## ZONING COMMITTEE STAFF REPORT

1. **APPLICANT:** Cullen, LLC **FILE #:** 14-355570
  2. **TYPE OF APPLICATION:** Site Plan Review **HEARING DATE:** 2/5/15
  3. **LOCATION:** 2138-2146 Grand Ave
  4. **PIN & LEGAL DESCRIPTION:** 052823410096; Summit Wood Lot 35, 36, and 37
  5. **PLANNING DISTRICT:** 14 **PRESENT ZONING:** RM2
  6. **ZONING CODE REFERENCE:** Section 61.402(c)
  7. **STAFF REPORT DATE:** 1/29/15 **BY:** Tom Beach and Larry Soderholm
  8. **DATE RECEIVED:** 12/23/14 **DEADLINE FOR ACTION:** 4/22/15
-

- A. **PURPOSE:** Site plan review for a new 4-story apartment building with 14 dwelling units and garage parking for 29 cars.
- B. **PARCEL SIZE:** 19,166 square feet including half the adjacent alley  
For lot area and density standards, half of the adjacent alley is considered part of the parcel per Section 66.2331.b:

## 2ND FLOOR PARKING DECK

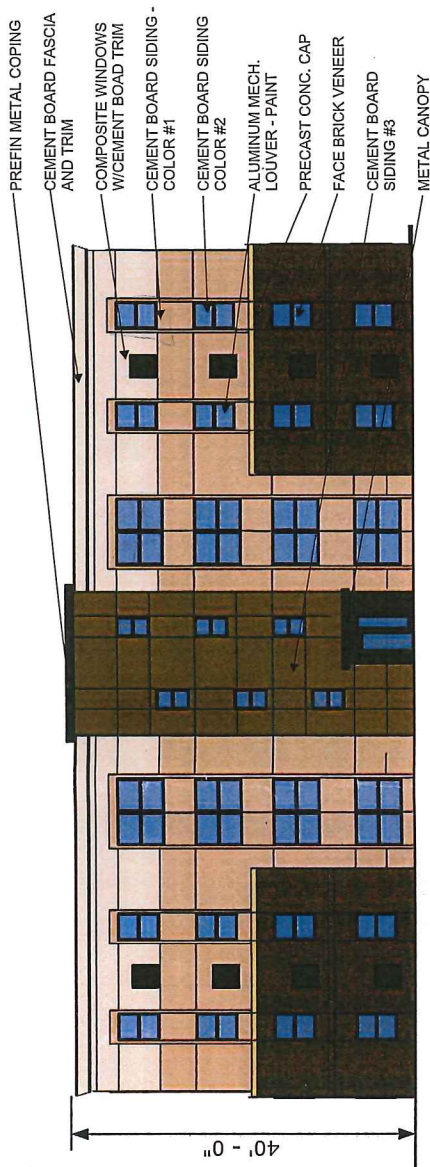
The parapet for the parking garage would act as a visual screen for cars. The parapet must be 4.5' tall to meet zoning standards for visual screens.

The maneuvering space for some of the parking spaces in the garage is tight, especially on the upper deck of the parking garage. Staff has asked that applicant to submit AutoTurn templates and revise the upper deck spaces if necessary. (The project has more parking than the code requires so eliminating a space or two would not affect the project's compliance with zoning standards.)

The applicant has told staff that he intends to change the swinging elevator gates shown on the upper parking deck to an overhead garage door (the same as the lower level.) This would simplify parking.

4. Approval by the Public Works traffic engineer of maneuvering for the parking spaces in the garage structure.
5. The parapet walls of the upper deck must meet zoning code standards for height (minimum 4.5'). In addition, they must be constructed to meet Building Code standards for side vehicular impacts.

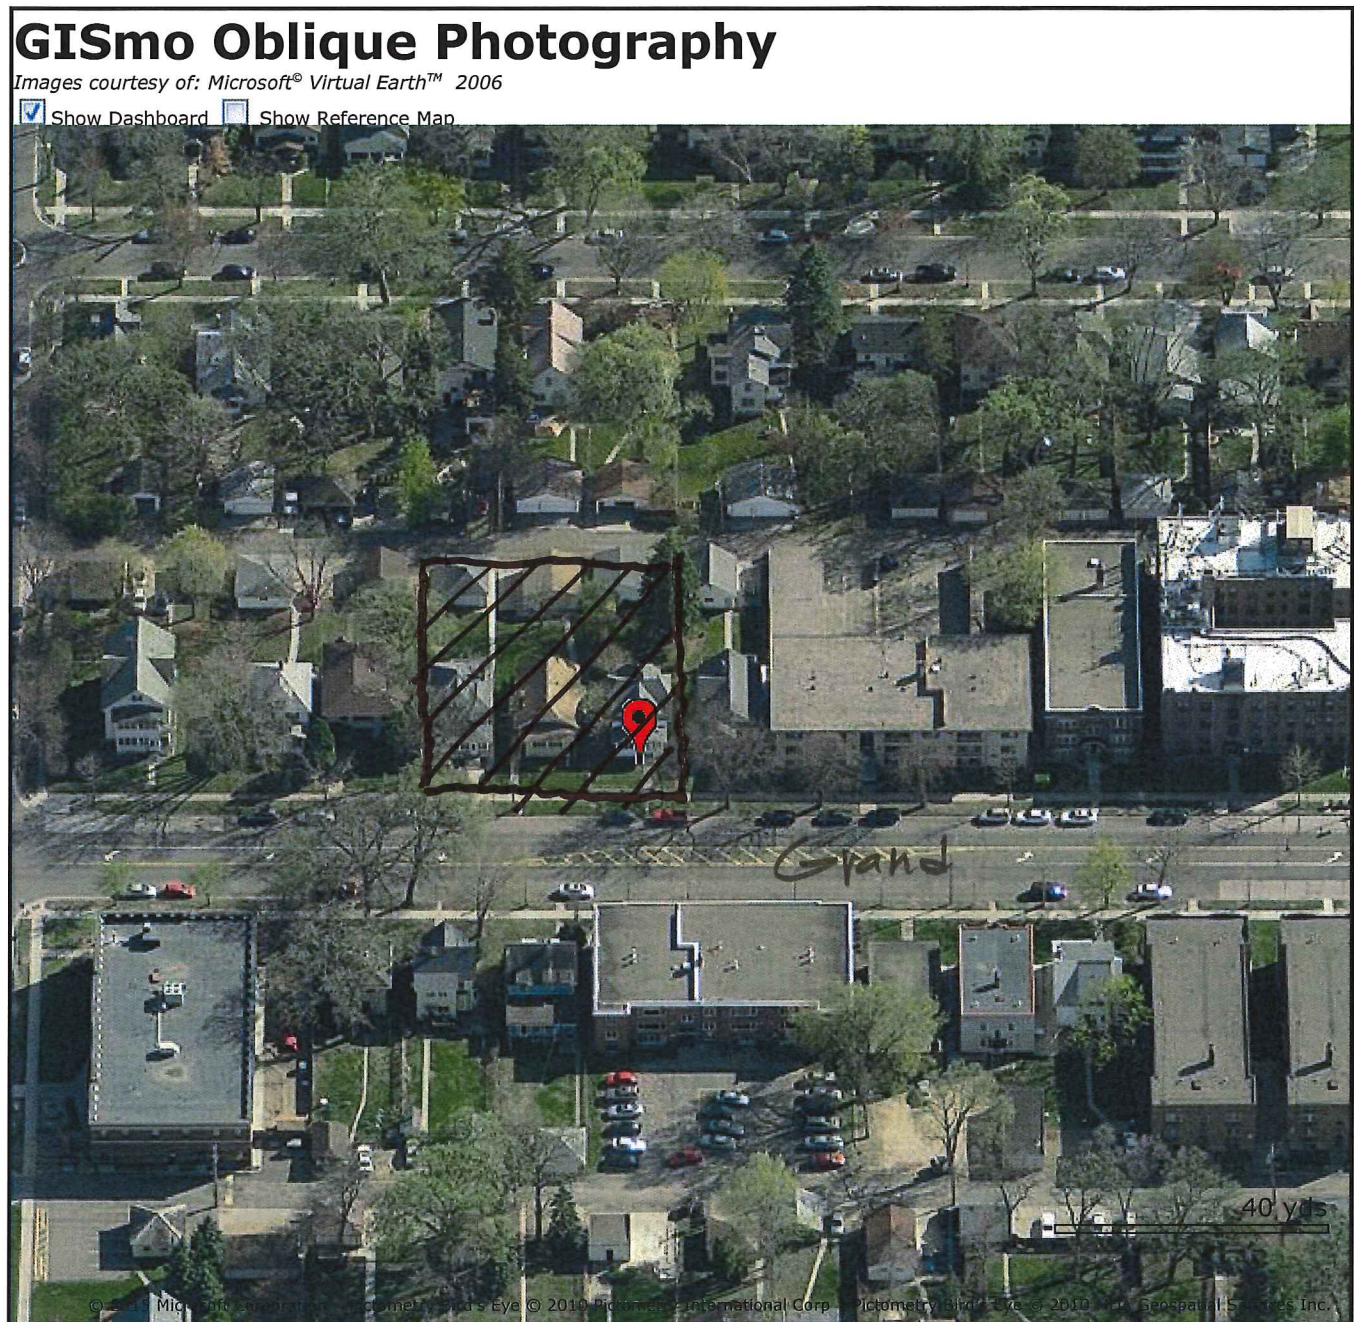
Staff visited a new apartment in Dinkytown that has an elevator similar to the one being proposed for the parking garage/ramp at West Grand Apartments. This elevator is indoors and the proposed elevator would be outside. The pump/motor assembly for the elevator is shown below. It would be located in a room in the garage/ramp.

Staff is getting more information about the elevator related to noise levels and operation in cold weather.

3. Approval of the car elevator by DSI Plan Review based on the submission of evidence that the elevator will work safely in all types of weather and will be reasonably quiet.
